# **Seismic Evaluation of the U1a Complex at the Nevada Test Site**

## ***Interim Report*** **SM98-24**

**November 4, 1998**

**Figure 4: The timber support and wire restraint for the air line piping.**

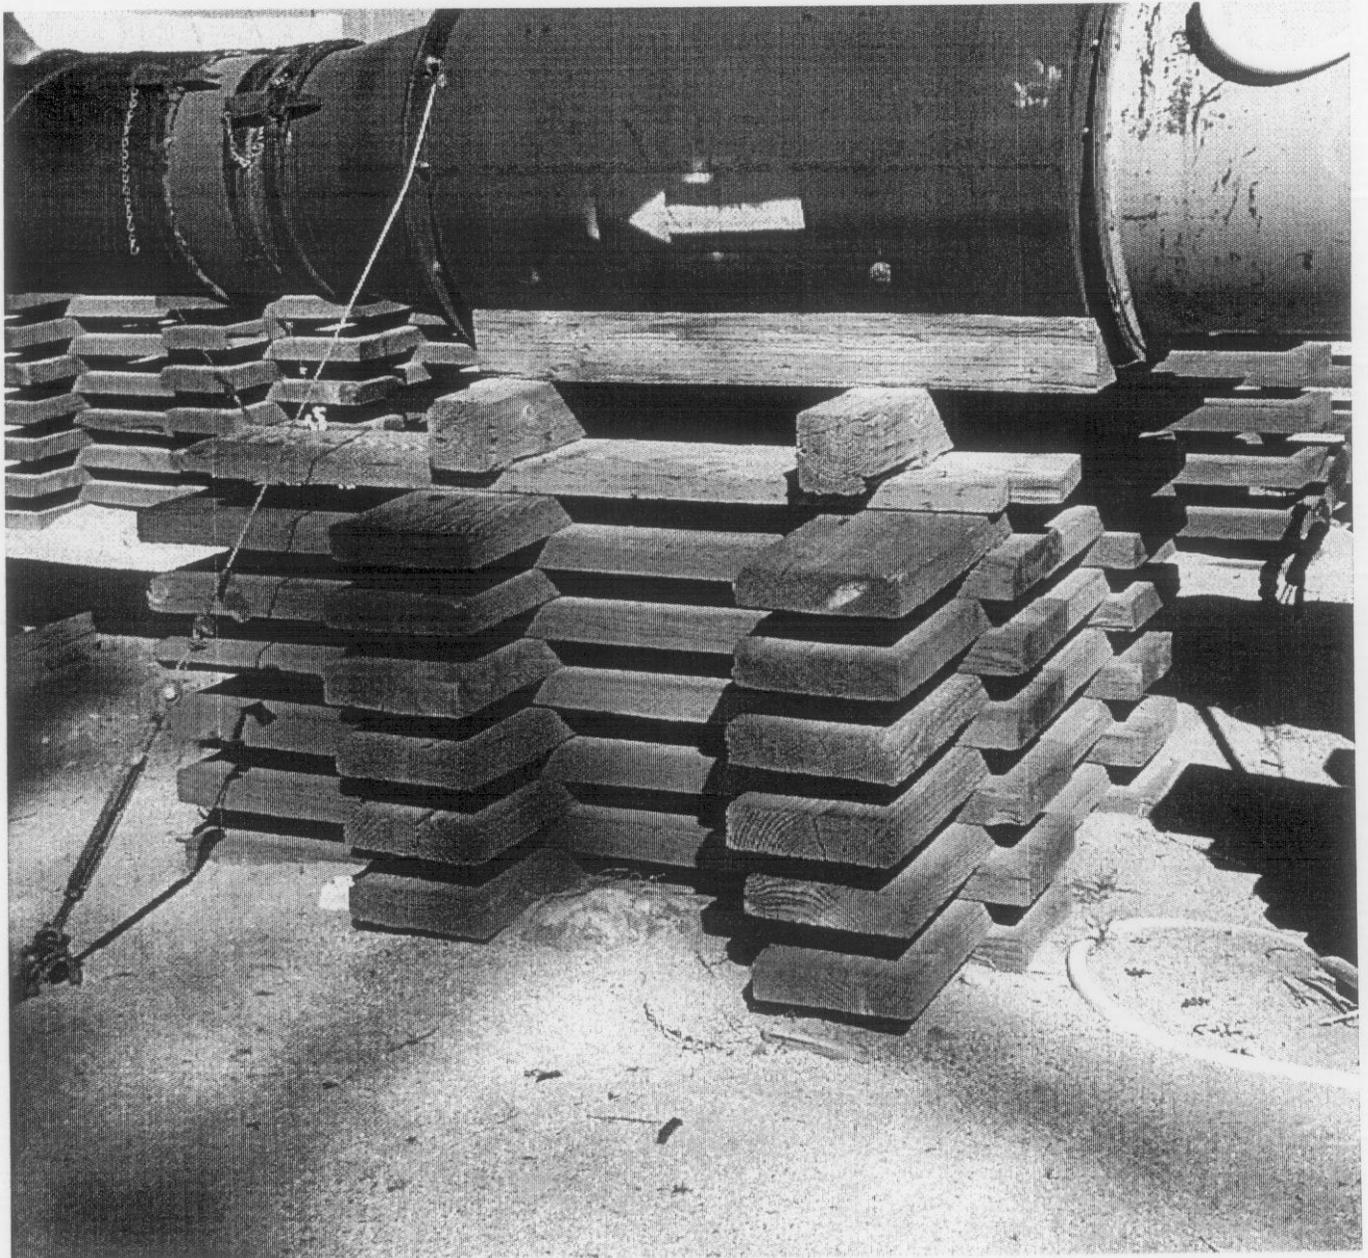
Recommendations were made to evaluate the Items #67 through #71 for lateral restraint. Figure 4 shows the air line being supported on timber (crib) and laterally restrained by wire. Such anchorage may not be sufficient for the air line system especially for the attached cantilevered valve (not shown in the Figure). Figure 5 depicts the wood block support for the emergency generator. Note that the block is smaller than the base plate of the generator; thus, evaluation was recommended.

**Figure 6:** An anchor bolt is missing on the right side of the cabinet.

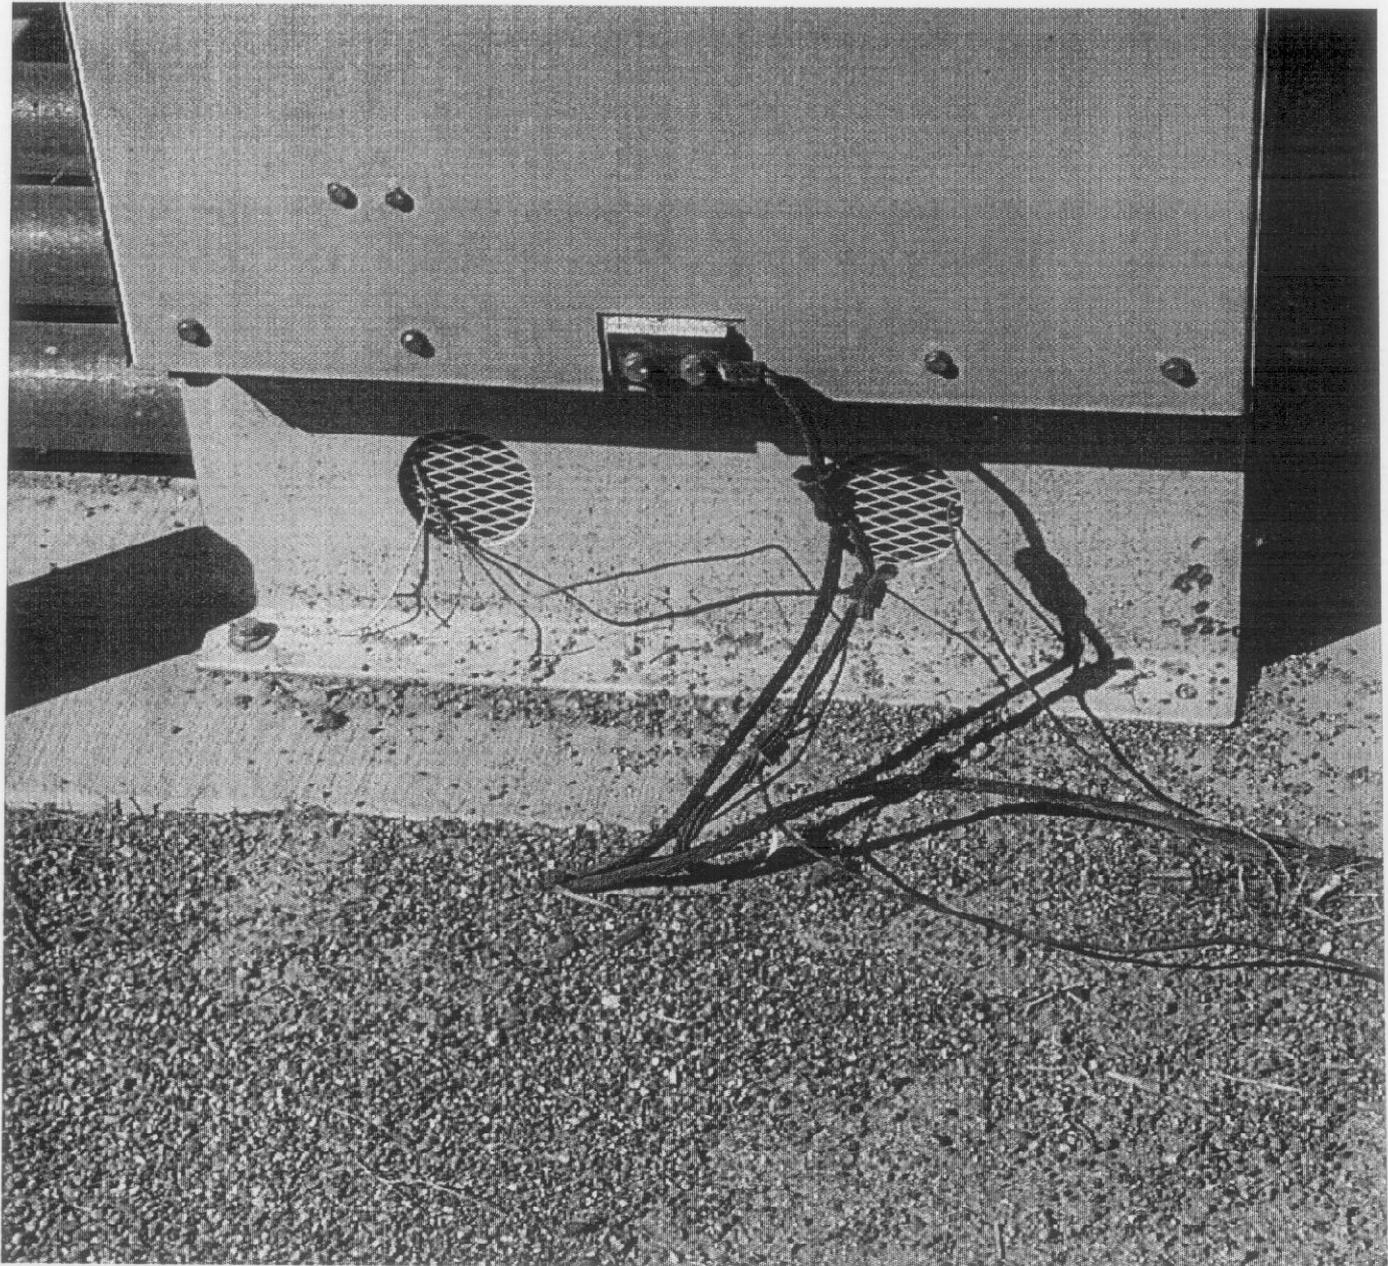
There are 28 PC-1 items marked for evaluation and they are tabulated in the Appendix F for easy access. Most of them are recommended for equipment anchorage. For example, Figure 6 shows missing bolts at the right corner of the cabinet. Figure 7 is an opposite view of Figure 6 showing a missing bolt and three conduits rigidly connected to cabinet on the right-hand-side of the Figure. The rigid connection is vulnerable to damage when the cabinet or the equipment is not properly anchored. Figure 8 is another example of free-standing equipment (high voltage switches) with rigid conduit connections.

**Figure 9: Free-standing equipment with flexible connection to cable and possible interaction with adjacent rack.**

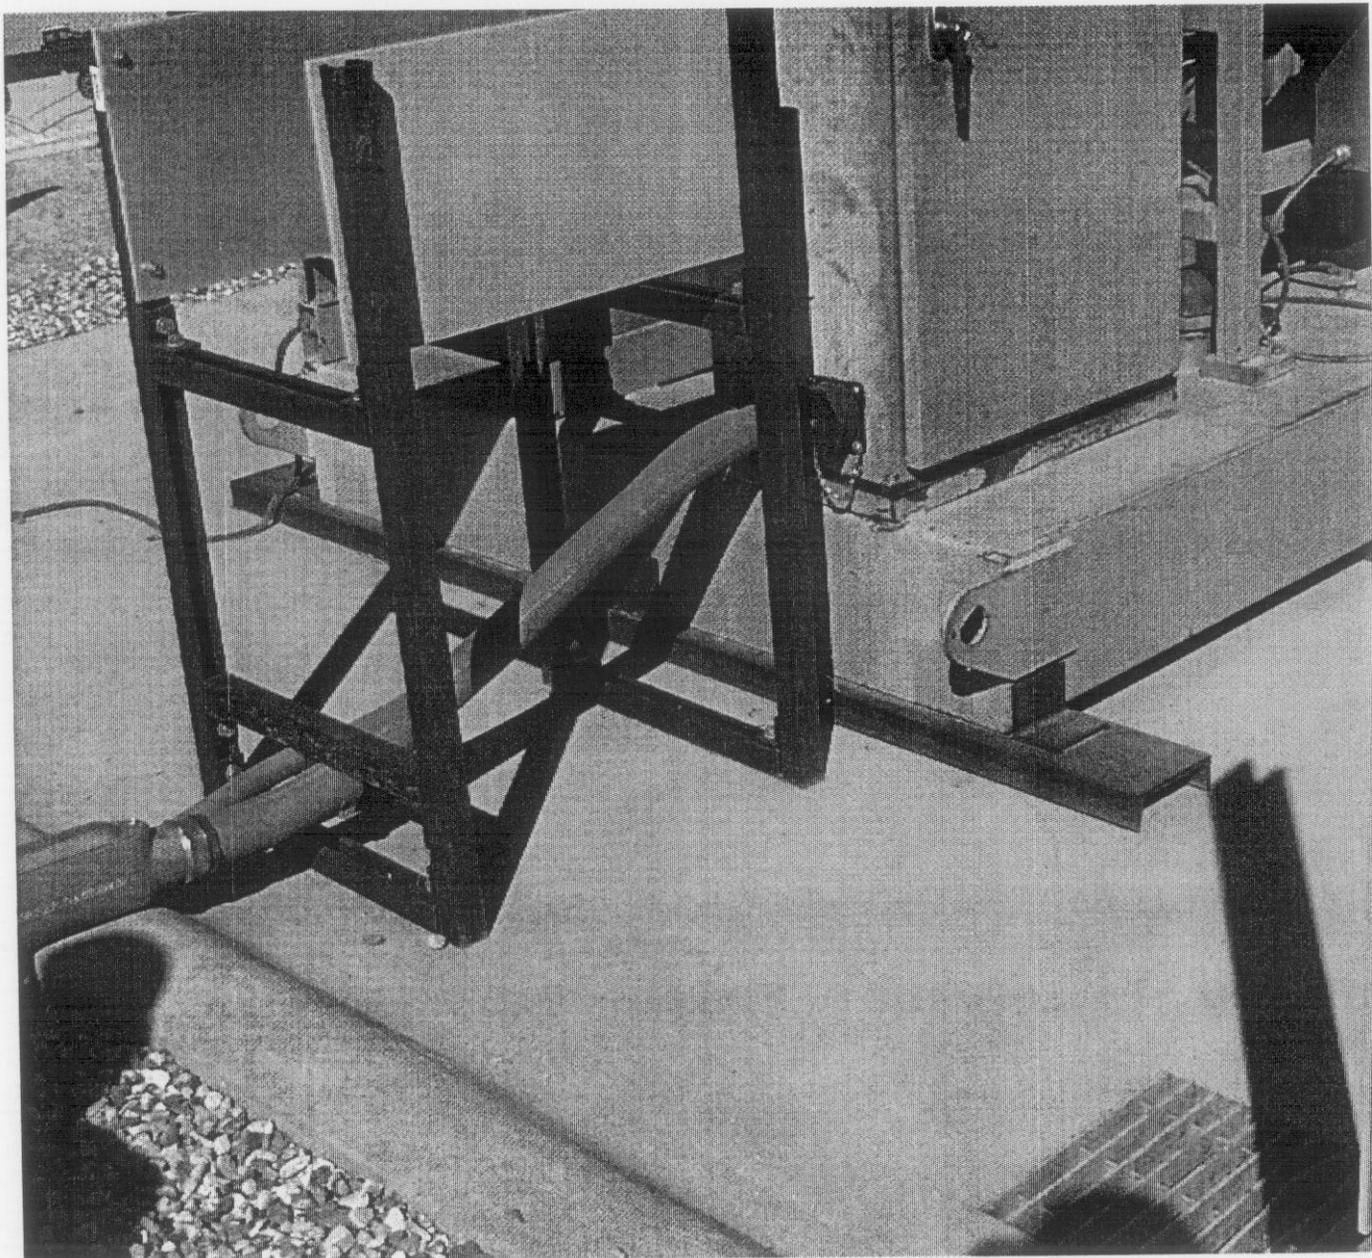
Figure 9 shows a free-standing equipment with flexible cable connection. If uplifting loads exist at the legs the equipment should be tied down to avoid seismic movement. Note that the small rack may have interaction with the flexible cable causing avoidable damage to the cable.

Figure 10: A water tank buckles at the support.

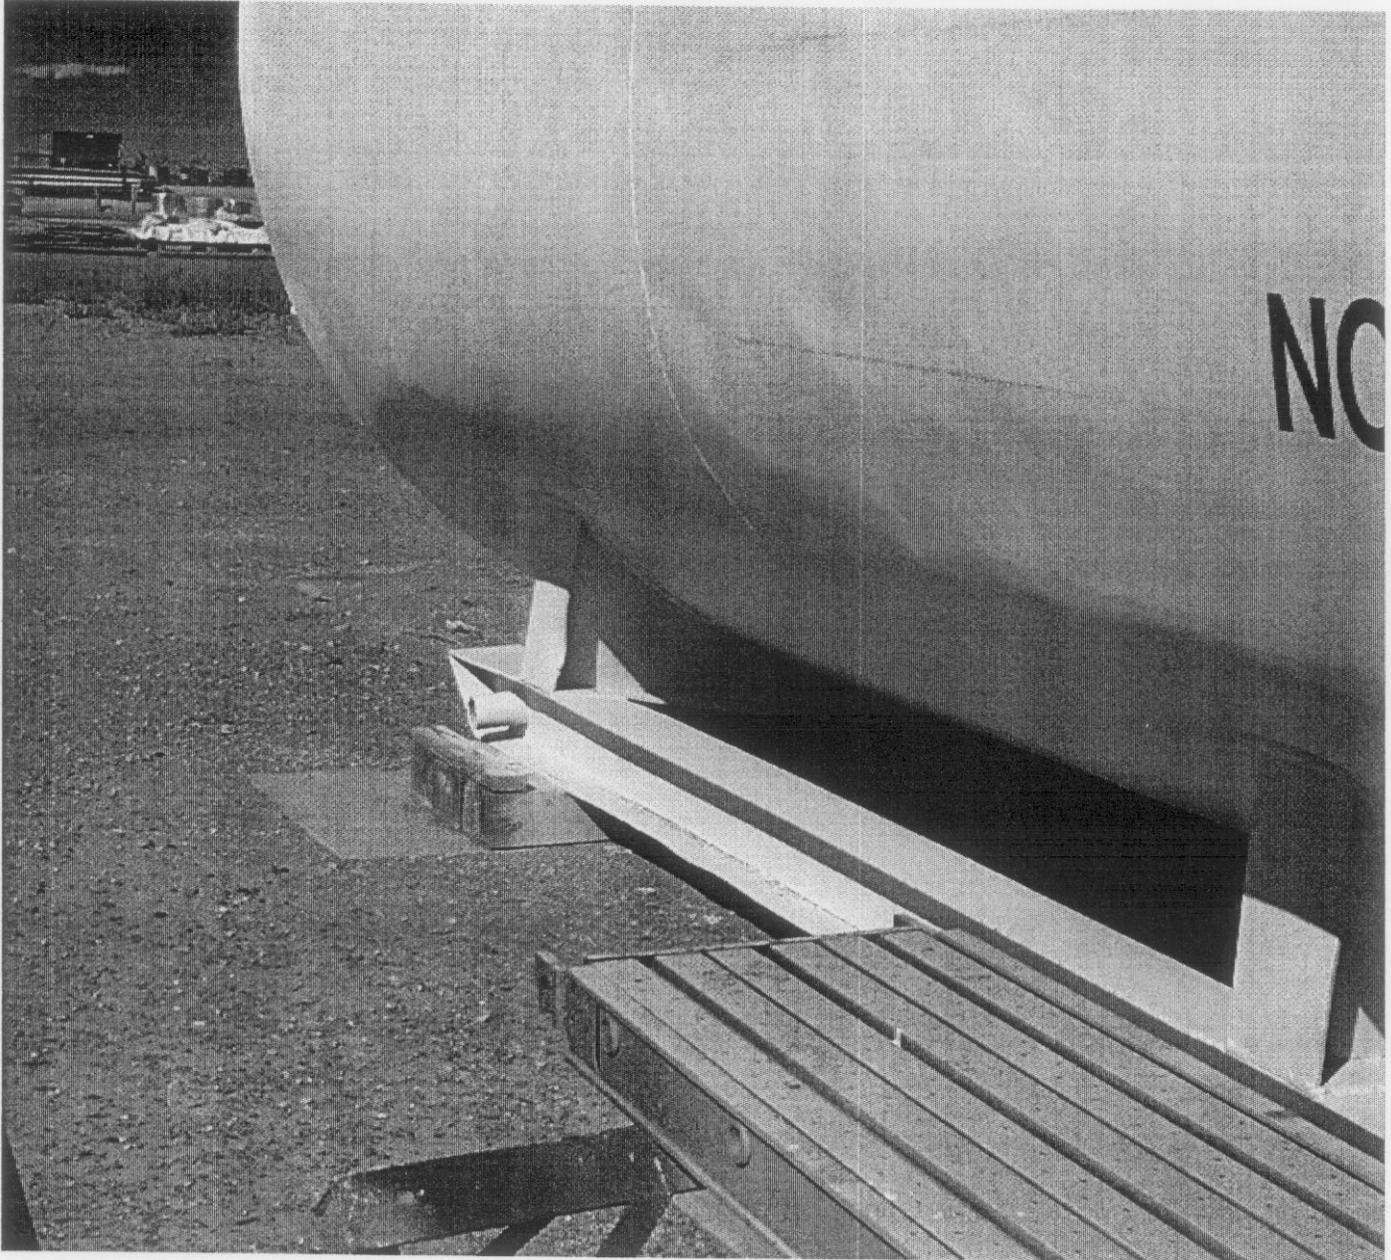
There are several utility water tanks at the surface facility that need to be anchored to the ground. Two water tanks are part of the shaft spray system while two others are the construction water supply. One of the horizontal tanks for the shaft spray system buckled at the supports, as shown in Figure 10, and was marked for evaluation. The weldment on two legs were damaged and should be repaired. Figure 11 is a close-up view of the damaged weldment at the front leg.

Figure 12: Free-standing bottles need to be restrained from falling.

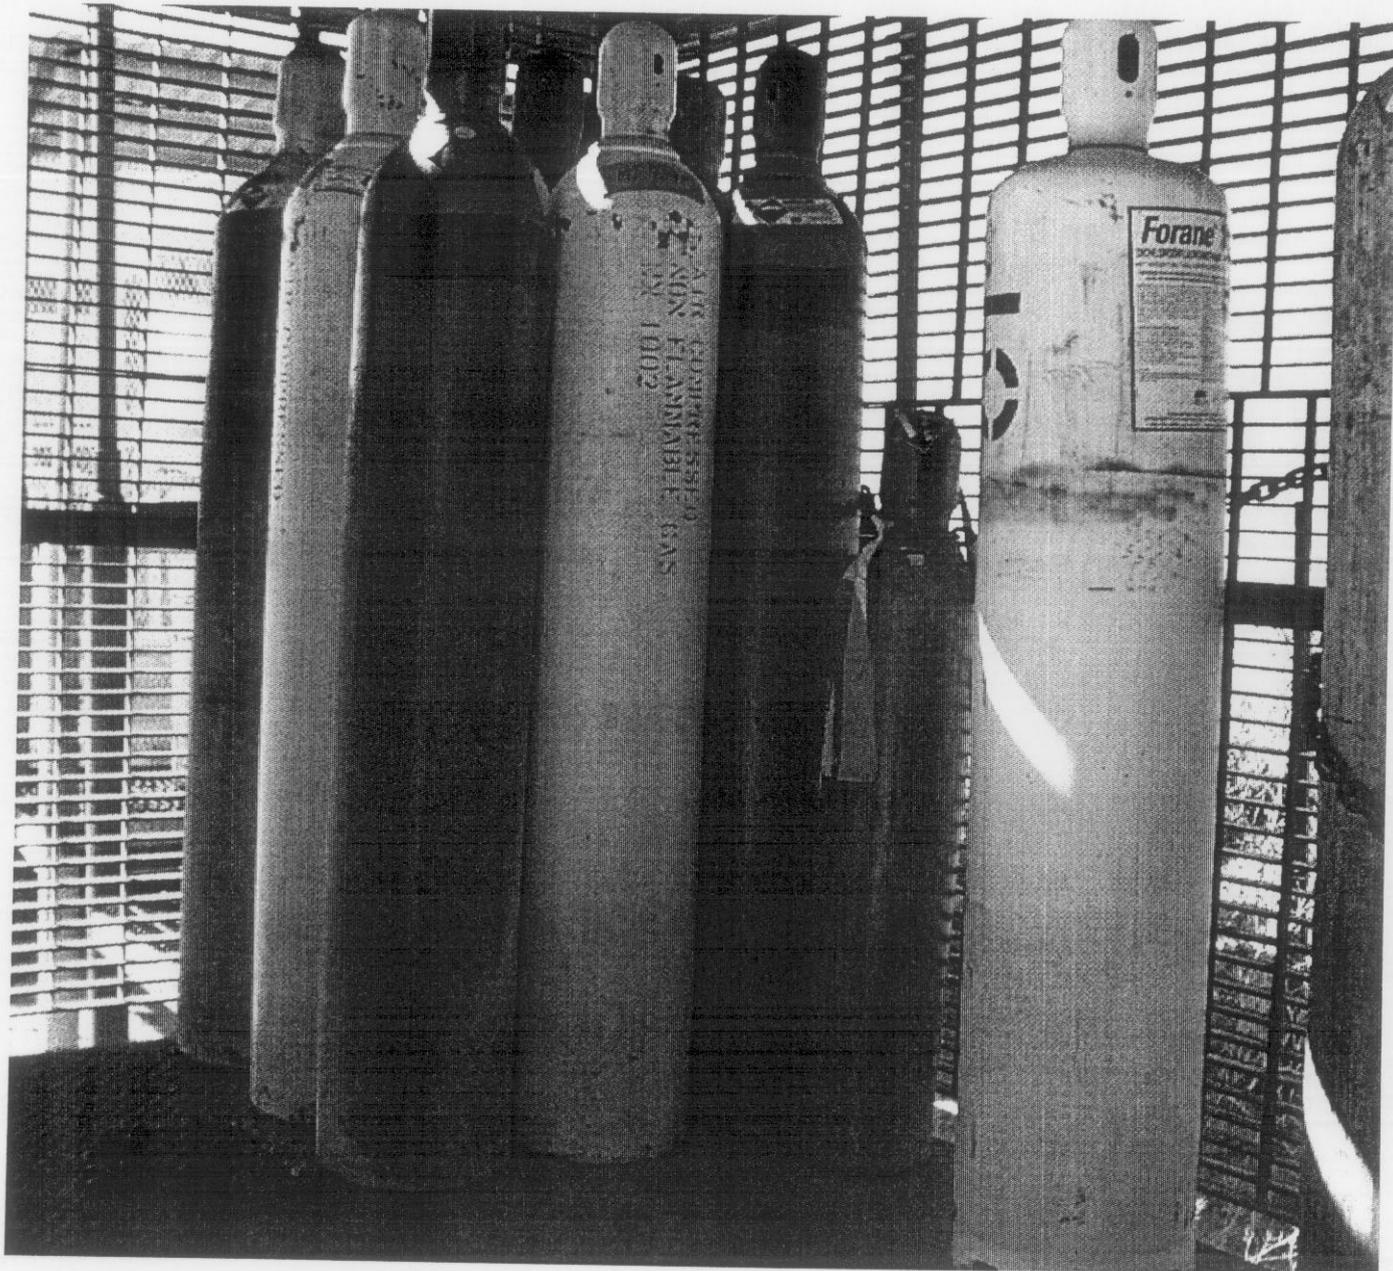
Gas bottles are stored in the sheds, located north of the assembly building. As shown in Figure 12 some gas bottles which were not restrained to the side of the shed could fall over during earthquake. Similar situation is shown in Figure 13 where the rack was chained across its opening but the bottles were not chained to the side of the rack to keep them from falling.

**Figure 14: Evaluation of the timber-pile response to earthquake motion is recommended.**

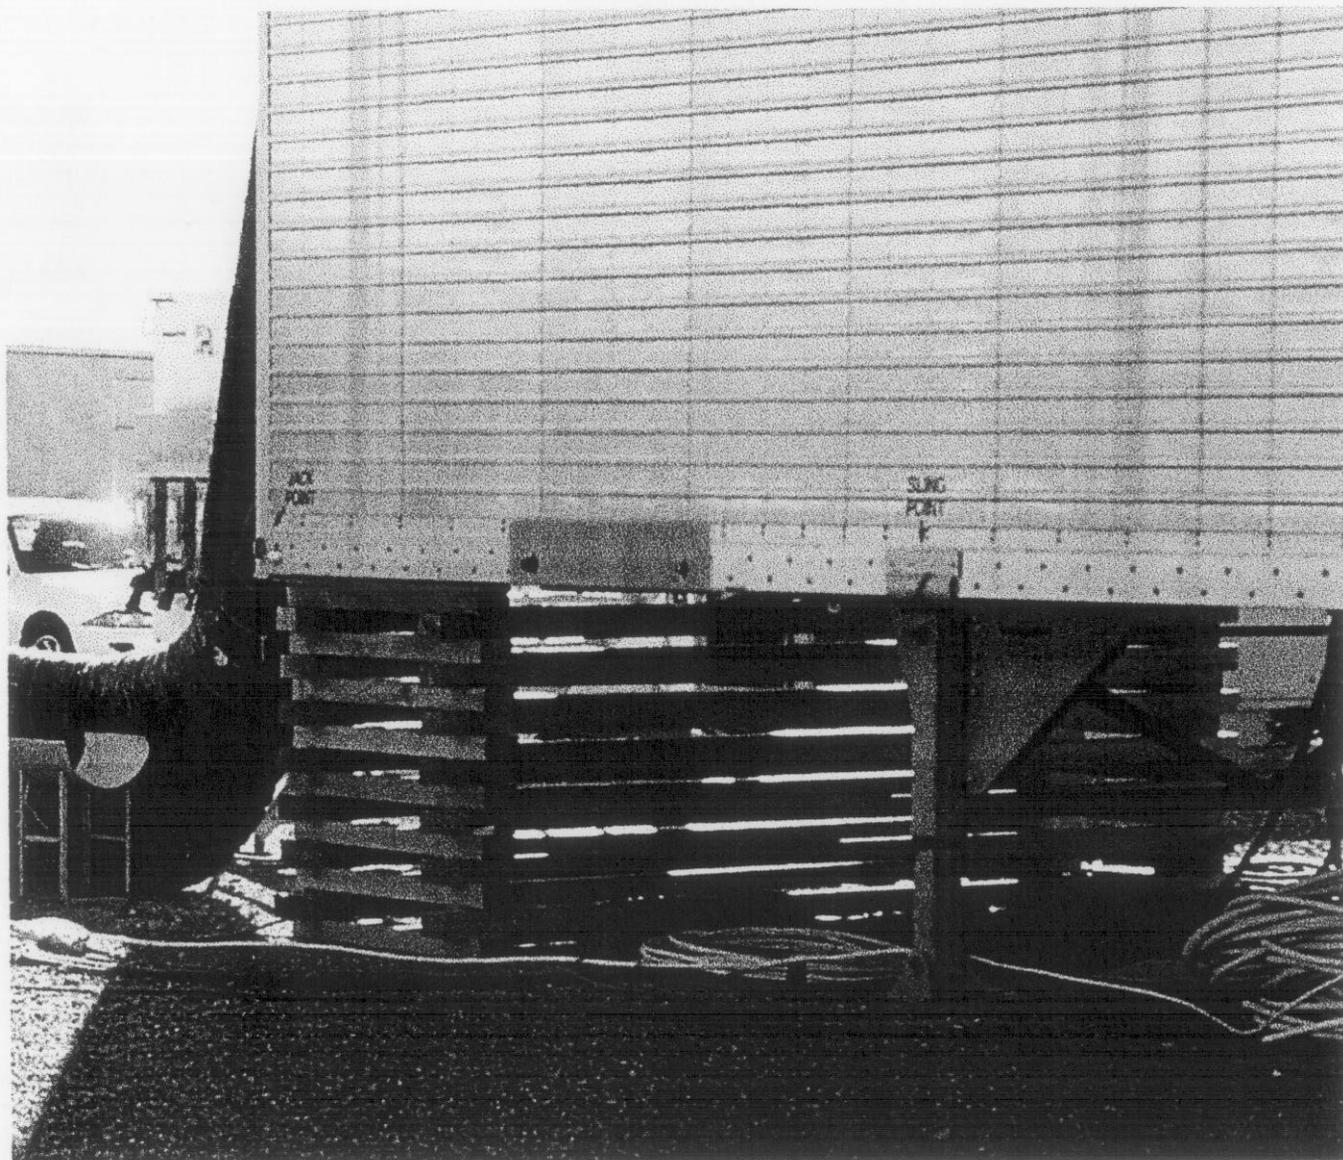
Some trailers are supported on wood cribs up to several feet above ground as shown in Figure 14. It is not clear that the wood cribs could remain intact during an earthquake; therefore, recommendation was made to evaluate the stability of the cribs. Some trailers are supported on wheels on one end and on small tripods on the other end as shown in Figure 15. It is possible that the wheels might experience significant movement that the tripods could overturn. It was recommended to limit the wheel rolling by shimming with blocks.
